May 1, 1920.

Regarding washout bridge recently constructed on the Chippewa Valley Branch two and a half miles west of Trevino, Wis., bridge known as M-18½. I have sketched below a section showing heights etc.

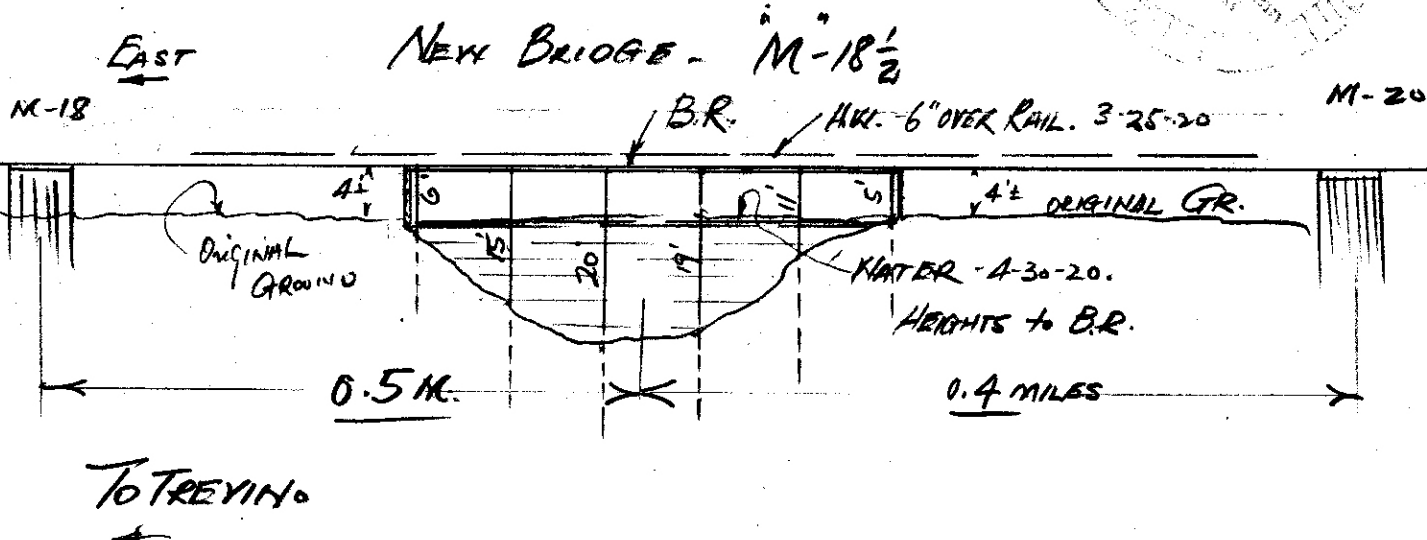
Hole shown scooped out under the bridge is entirely on the Right of Way; R/W here being 100' wide. On March 25th, on account of an ice jam in the Chippewa river to the south (West), water went 6 inches over the track in this vicinity causing this bad hole here and several smaller ones for a quarter of a mile east.

Chief Carpenter Ostrom states that during his time of 13 years water in this locality has never been over the track before but has been up to it several times. He recommends that this bridge be maintained. Bridge is of new material, standard drawing number A-5600.

I agree with Mr. Ostrom; think we should maintain this bridge until time for renewal at least. At that time a further investigation can be made for possible filling.

1400± yds req. to fill.
